# Building Code of Australia 2022 Report

Report for BCA Compliance

PROJECT NAME: Minarah College Campus - 268 & 278 Catherine Fields Road, Catherine Fields NSW 2557  
PROJECT NUMBER: GDL220105  
DATE: 04/11/2025

- Fire Compartments
- Exits location
- Stair Precis Table
- Travel Distances

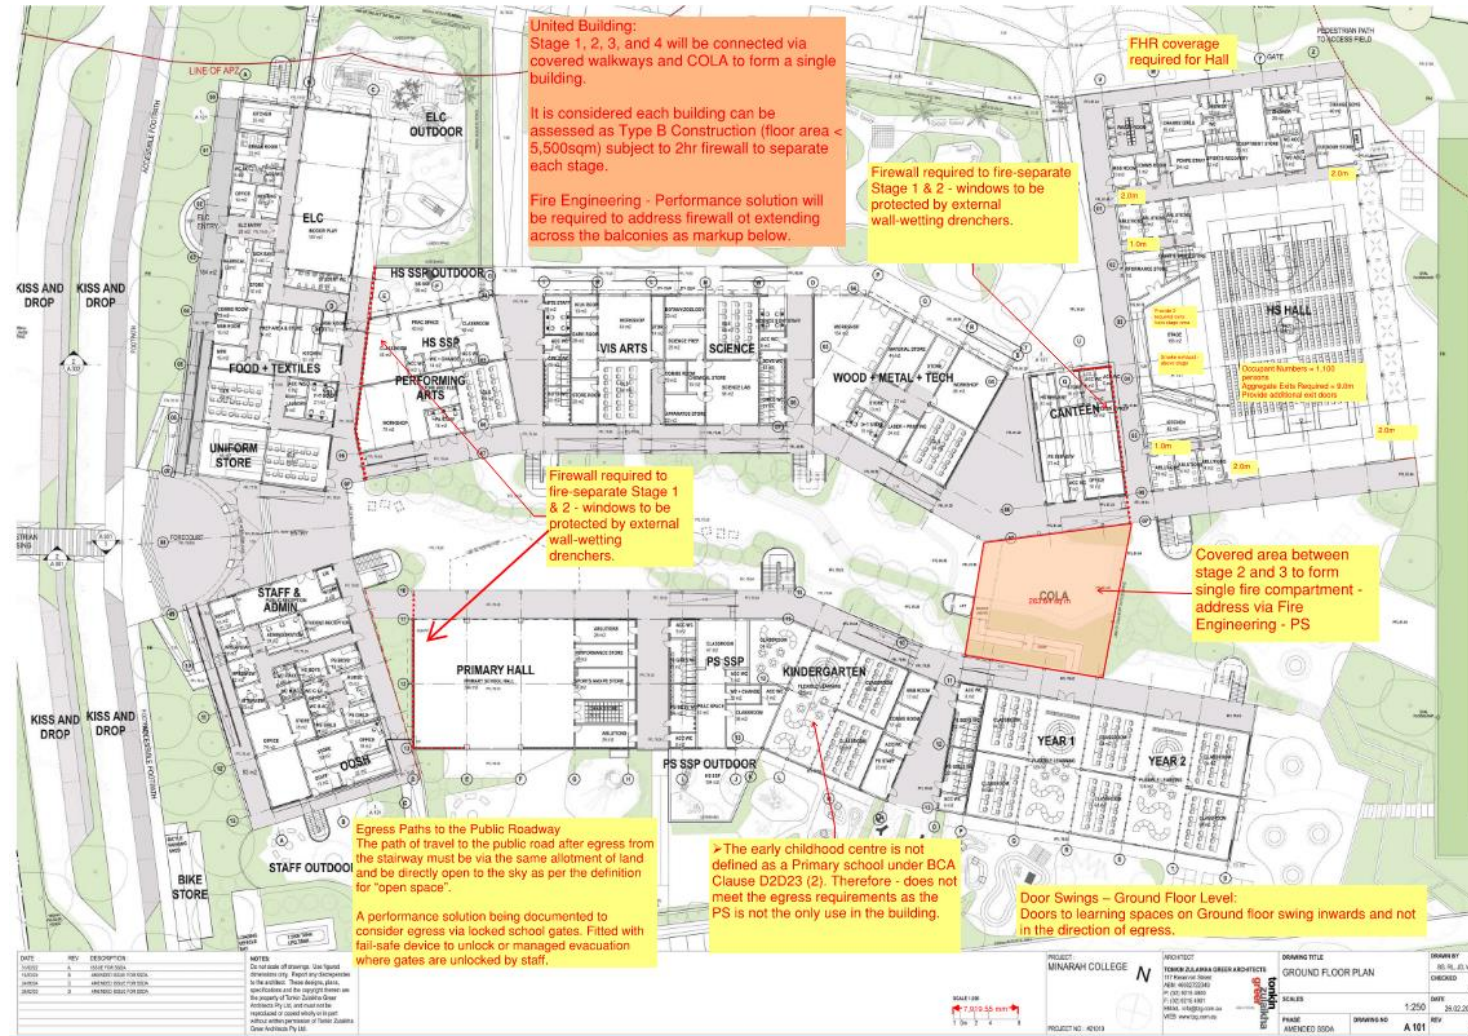
Refer to appendix A which indicates egress assessment with markup travel distances. Consideration being given to the documentation of performance solutions from a fire engineer to address extended travel distances.

### Fire Compartmentation:

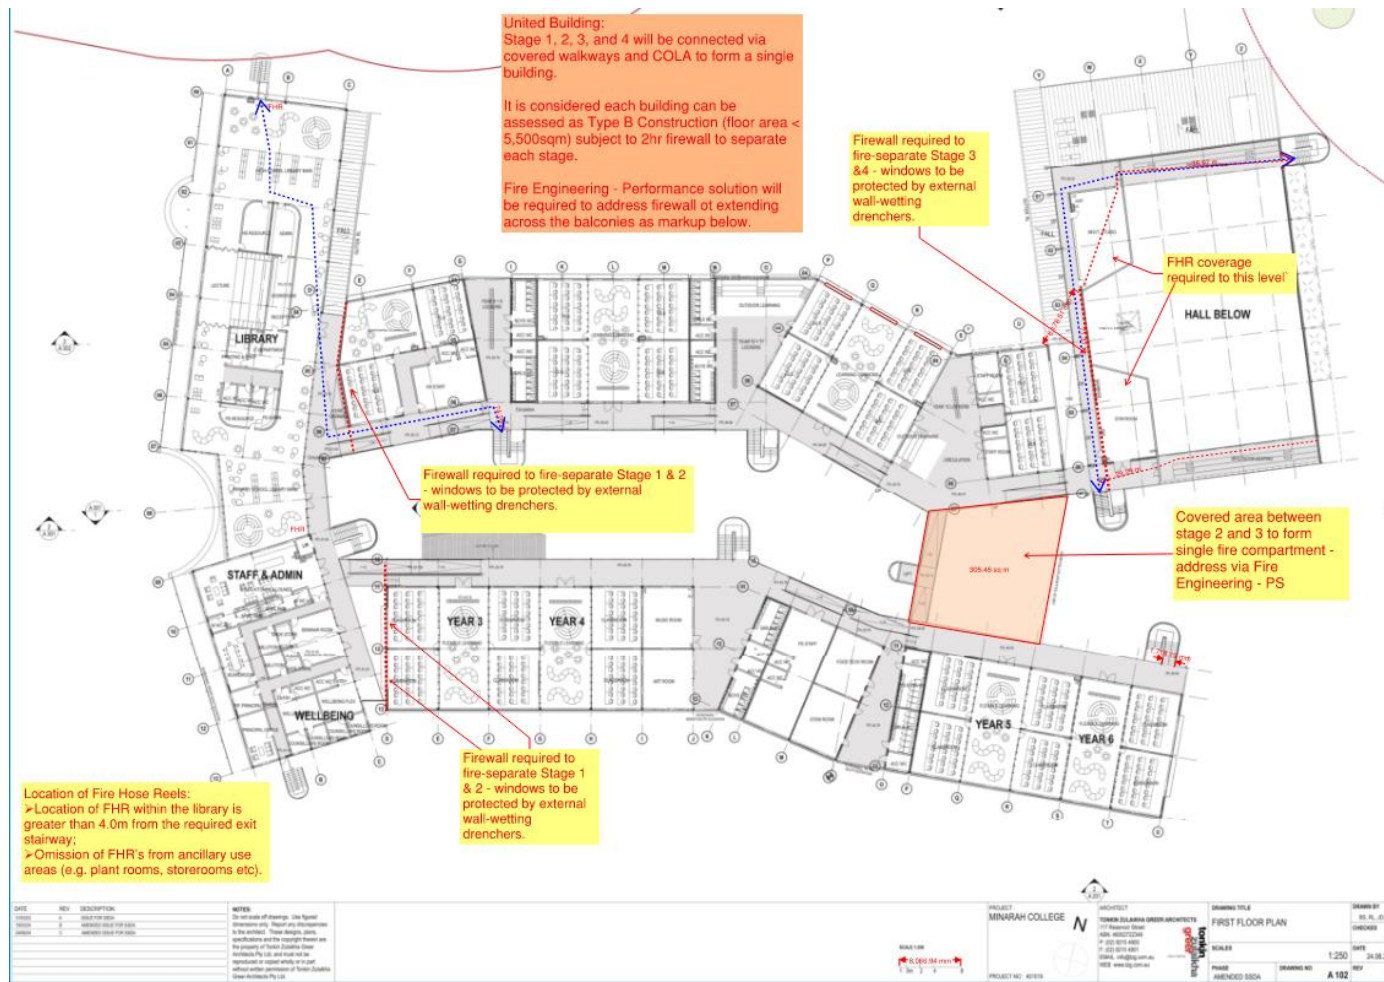
The progressive construction of each stage (stage 1 to 4) will increase the floor area to 11,746 m<sup>2</sup> for the school campus which will exceed the maximum fire compartment size for Type B Construction. A fire wall will be required to fire-separate each stage with any windows located within the walls to be suitable protected by wall-wetting drenchers (Refer to Appendix A).

Each stage will be connected via the open walkways & Outdoor Learning areas within each storey to form a United building. The open balconies/walkways are defined by BCA2022 as the floor area for purposes of fire compartmentation.

A performance solution will be required from a fire engineer which will assess the open balconies of not contributing to the fire load as justification for not continuing the firewall across the walkways to the perimeter.
